Harcourt House, 16-17 Haringey Park, N8 9JB

22.05.24

- 1.1 Ashton Architecture has been instructed by the leaseholders of Harcourt House owners to review the submission information relating to application ref HGY/2024/0921 for the erection of one additional storey at roof level to existing building to provide two self-contained apartments, plant and associated works.
- 1.2 The leaseholder group has raised concerns with how the application information has been presented, and the potential physical implications for the existing building which are not highlighted.
- 1.3 This statement highlights specific discrepancies presented in design proposals, but does not seek to impart any qualitative view on the design concept itself.

Diagram 3.9 Common escape route in small single stair building

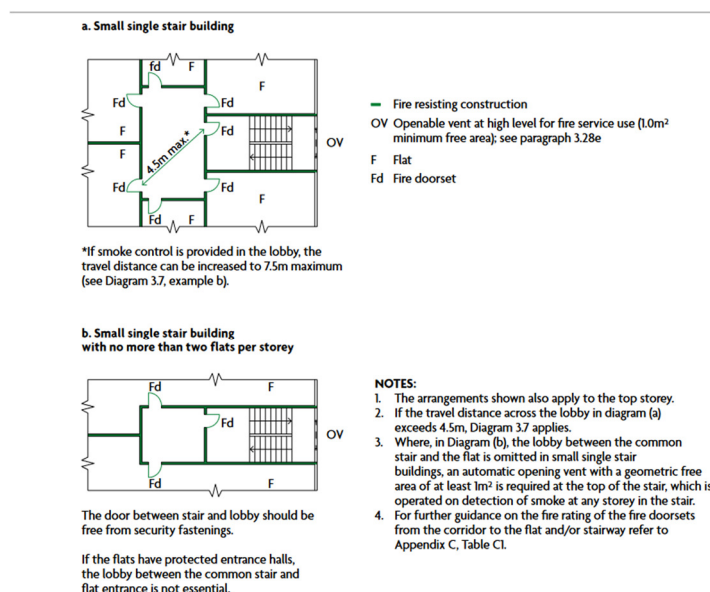
- 2.10 The 2022 update of British Building regulations Part B1 [paragraph 3.28] states that a small building can have a single staircase, provided it meets the following criteria;

- A. The top storey of the building is a maximum of 11m
 - B. The single stair can be protected by separate lobbies as per the diagram below.

The application proposals do not currently meet either of these criteria. The introduction of an AOV may satisfy point B [as noted in diagram 3.9 below] if all other flats have internal protected entrance lobbies – no evidence of this has been provided with the application proposals. In addition, no AOV is shown on the application proposals.

However, the more significant issue remains that the single staircase does not meet the requirements of Part B of the Building Regulations where the building has a top floor level over 11m.

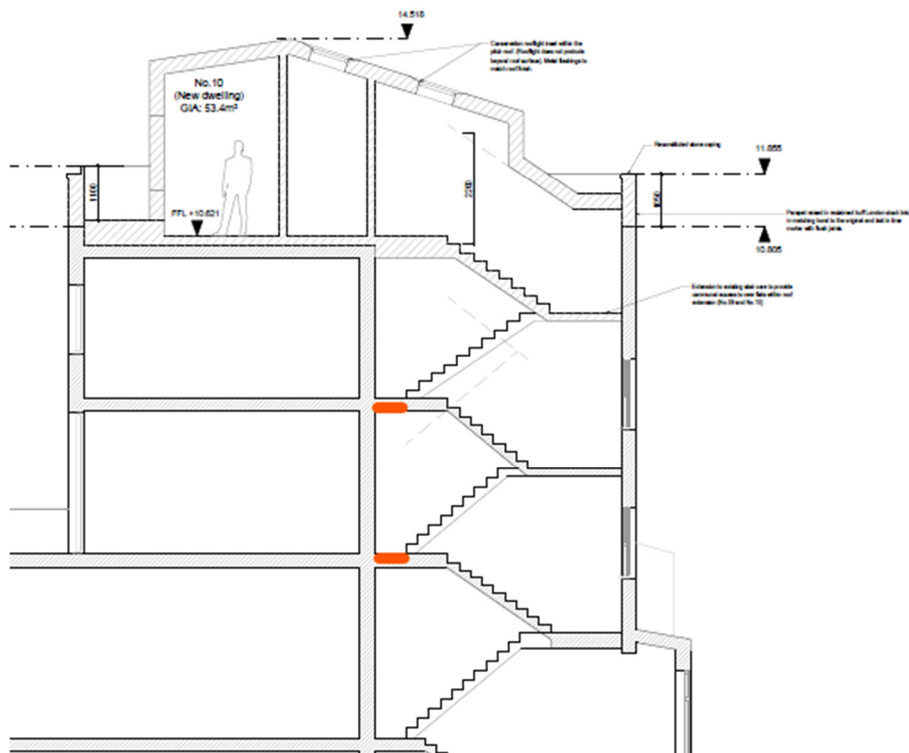
- 4.1 The design information supporting the application proposals does not include any details on the existing or proposed bin and recycling facilities on the site.

- 4.2 The design information supporting the application proposals does not include any details on the existing or proposed cycle storage facilities on the site.

- 4.3 Any storage will require a weatherproof enclosure, which will impact on the design proposals as currently presented.
- 4.4 The proposed application drawings do not show any services penetrations through the walls or roof, for items such as flues, extraction, soil pipes and ventilation. Given the proposed homogeneous appearance of the proposals, these fittings will likely have a strong visual impact on the proposals.

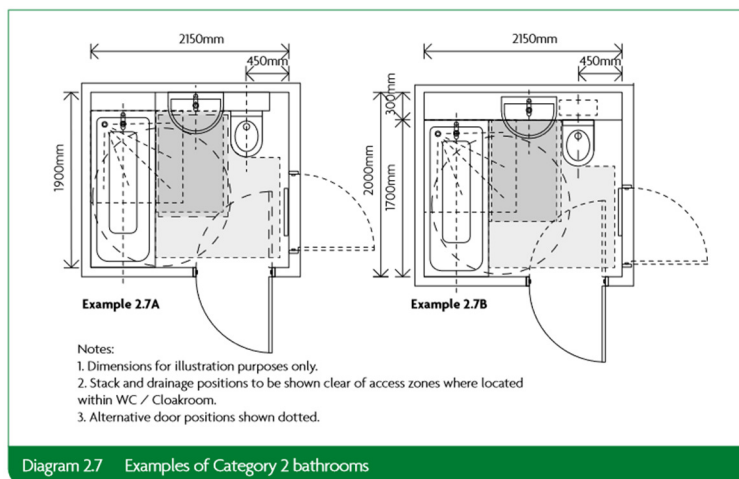
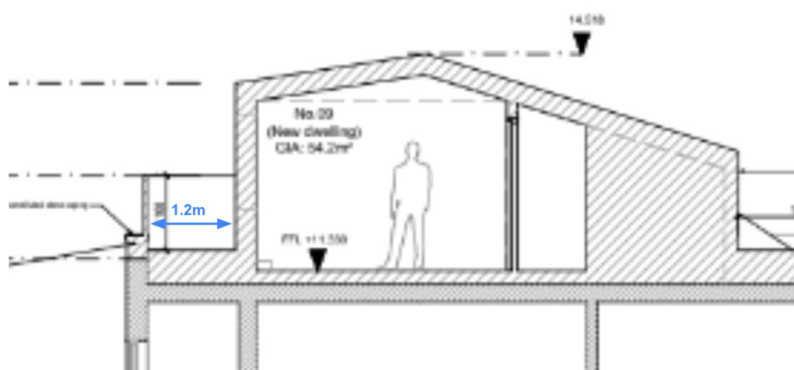
- 300mm leading edge nibs not provided on apartment entrance doors; *a 300mm leading edge nib to main doors is a requirement of Part M4(2)*
 - The bathroom does not meet the requirements set out in diagram 2.7 in AD Part M4(2):

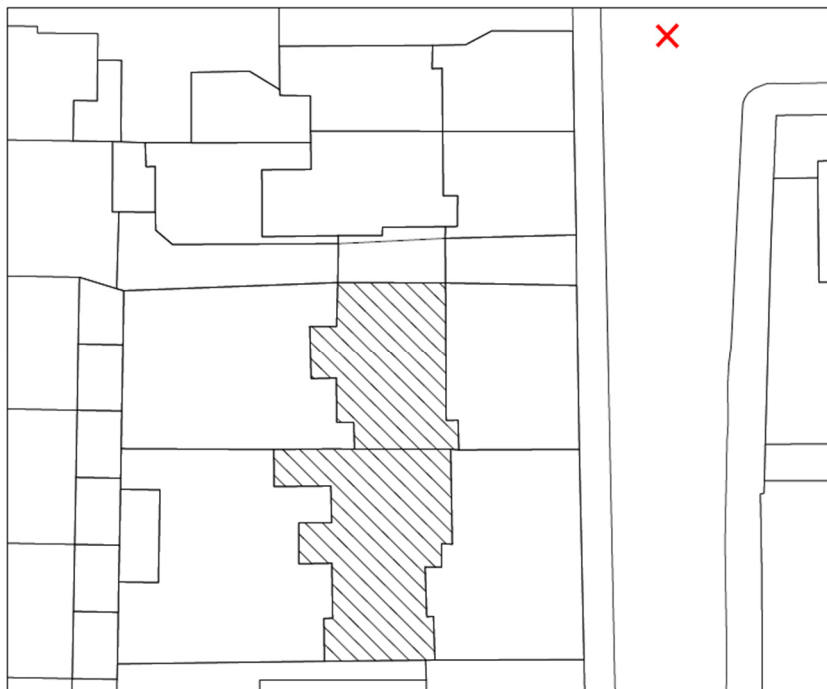
- 5.1 The following CGI graphic has been submitted as part of the application documents, showing the proposed changes to the existing building – with the rooftop addition not in view.

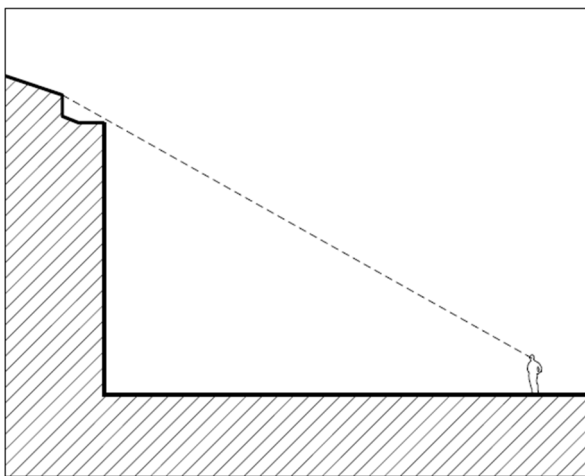
- 5.2 It appears the CGI position is taken from the centre of the Haringey Park road, in the position marked X below:

- 5.3 Our assessment is that the proposed additional storey to Harcourt House will be visible from this position, as demonstrated in the sketch section below – noting that the ground line is lowered by 0.5m to account for the approximate street levels:

- 5.4 It would be helpful to provide clarity on the exact position the CGI is positioned from, in order for the visual impact of the application proposals to be fully understood.
